Base Realignment and Closure Cleanup Team Meeting Minutes
Groundwater Modeling Working Session
Former George Air Force Base, California
22 March 2006

2.0 Feedback on Response to Regulatory Comments - Model Development and Flow Calibration Results

The AF distributed a handout with sensitivity parameter results (see **Attachment 2**). The sensitivity results represent the transient calibration over the entire time of the simulation. RMSE stands for the root mean square error.

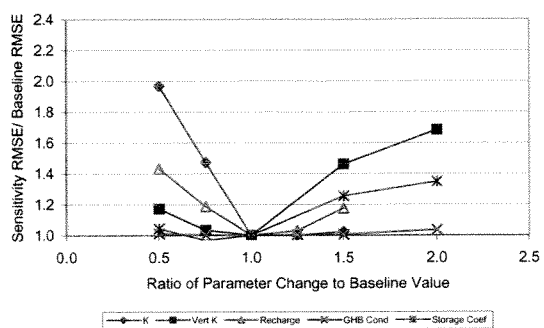
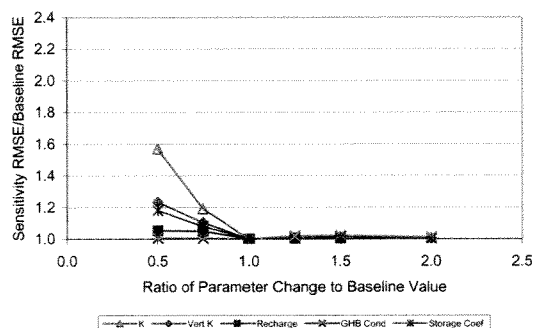
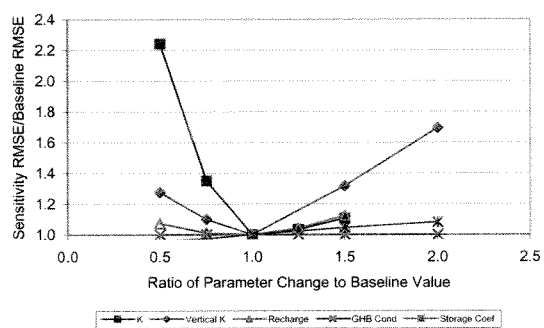
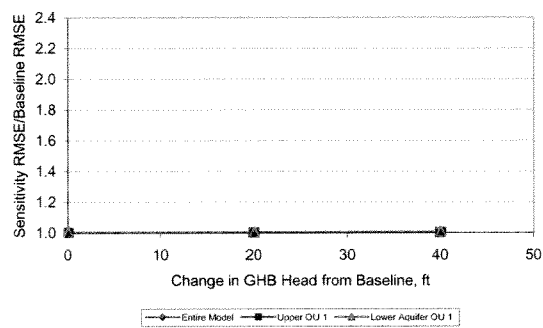
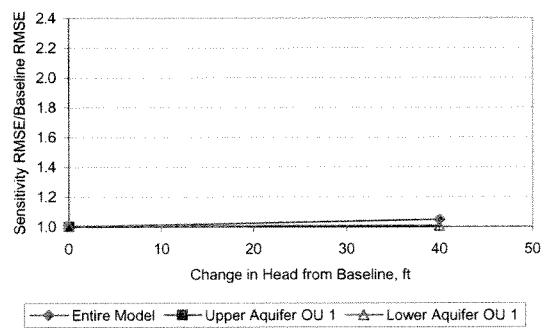
The AF explained vertical and hydraulic conductivities are the most influential parameters effecting results. Vertical conductivity is more sensitive as its value gets larger. Hydraulic conductivity is only sensitive if its value is smaller.

The model boundary is far from OU 1 and the Adelanto fault, so general head is not sensitive to the OU 1 area.

The USEPA indicated sensitivity analysis can be masked if sensitivity is not done in its natural physical range. This would apply to all parameters, even those that are not showing sensitivity. If a parameter is already sensitive, this could further distinguish which parameters within each model layer are more sensitive. One could also apply sensitivity analysis to hydraulic conductivity in different zones. Sensitivity analysis can show different data gaps. The AF agreed and will increase the sensitivity analysis for the final scenario by up to 10 times.

Detailed sensitivity analysis will be completed for transport calibration after the final scenario is chosen. The AF indicated it would be of further value at that point. The USEPA agreed that completing sensitivity analysis after scenario runs are completed is appropriate. The AF indicated it is most cost-effective to perform modeling now.
